**Review of IWM study of river
bank erosion management in
Polder 29, Khulna,
Bangladesh**

1221278-000

Summary

Figure 2.1. General river planform development around southern part of Polder 29 in period 1984-2010 (source: Landsat images at <http://world.time.com/timelapse/>).

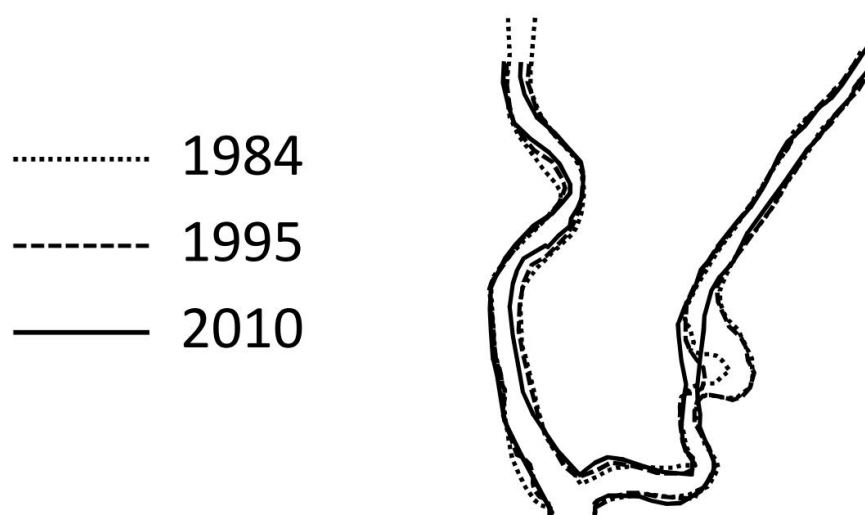
The current management of river bank erosion along Polder 29 is based on the principles of “adaptive delta management” and “living with water”. Wherever bank erosion threatens the embankments, the embankments are retired to a new location. The evolution of river planforms in the 25 years between 1984 and 2010, presented in Figure 2.1 of the present document, demonstrates that the river banks are mostly relatively stable. The planimetric changes due to bank erosion are small compared to the planimetric changes of the major rivers Brahmaputra-Jamuna, Ganges and Padma. The current adaptive approach thus seems feasible. The objective of the study, however, is to develop an approach for erosion protective work, irrespective of the costs involved. This leads to proposing bank protection over a length of in total 3 km. The capital investment for this protection can be estimated roughly to be in the order of a million euro, entailing subsequent maintenance costs in the order of 100,000 euro per year. The report does not present any economic underpinning for this solution. The costs have been compared neither with the annual damage due to erosion nor with the costs of retiring the embankments. Such a comparison is recommended for a good evaluation of different alternative solutions.

IWM (2015) analyzed river planform evolution on satellite images from 2000 to 2015. In order to extend the period of observation, Figure 2.1 of the present document presents the river planform evolution on satellite images from 1984 to 2010. The river banks are mostly found to be relatively stable, with the exception of the bank at Chandgar. Here prominent bank erosion occurs in relation to the straightening of a river bend. Figure 2.2 of the present document shows this development along with an interpretation of the associated main bank erosion. Extrapolation of this development suggests that substantial bank erosion may proceed to Jaliakhali and even the bank East of Baroaria. Figure 5.8 shows, however, that no protection is planned along that vulnerable bank.

Figure 2.2. Local river planform development (top) and corresponding interpretation of main bank erosion (bottom) at Chandgar in period 1984-2010 (source: Landsat images at <http://world.time.com/timelapse/>).

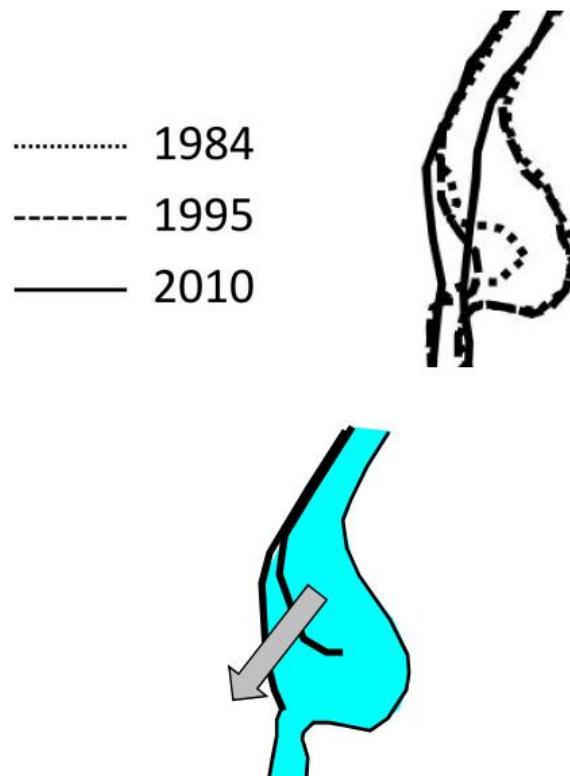
Figure 5.8 shows that no protection is planned along the bank at Jaliakhali. Extrapolation of the interpretation of bankline development in Figure 2.2 of the present document suggests, however, that substantial erosion may be expected there in the near future. This erosion might proceed even further up to the bank East of Baroaria.

Flat slopes and accreting environments offer possibilities for Building-with-Nature-type of solutions. Figure 2.2 of the present document suggests that the wide river area at Chandgar might be suitable for this. It might be possible to dredge the dying bend of this area and to dump the dredged material in the channel along the actively eroding bank. A feasibility study for this solution is recommended.
